FIELD INSPECTION REPORT

Project Name:	Mountain Valley Pipeline	Inspector:	Matthew Grant
Inspection Date:	Monday, May 13, 2024	Project Contact:	Brian Clauto
Spread I: Franklin	Sta 13440, 13497-13498, 14235-14250 FR 293.02, MLV AR32 ATWS 693, 350, 351, 351a	Weather:	Dry

Figure 4: Near St 13498, CE was not in place.

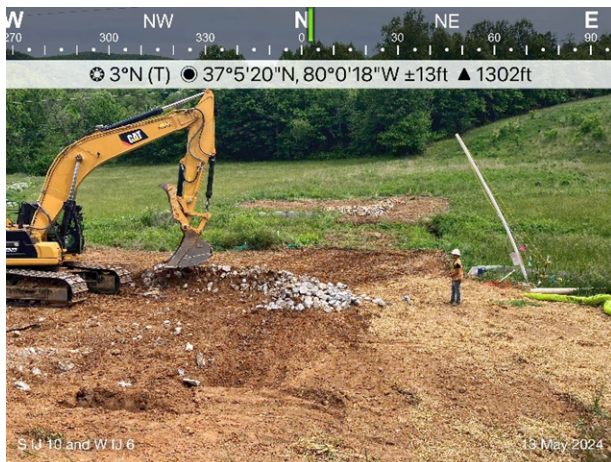
- Sta 13498 no perimeter controls, follow construction sequence before land disturbance begins
- Sta 13497 no construction entrance at Cahas 2, CE was removed before land disturbance was completed. Do not remove CE before land disturbance is completed.

Recommended Corrective Action: Maintain and install all controls per the approved PSS&S.
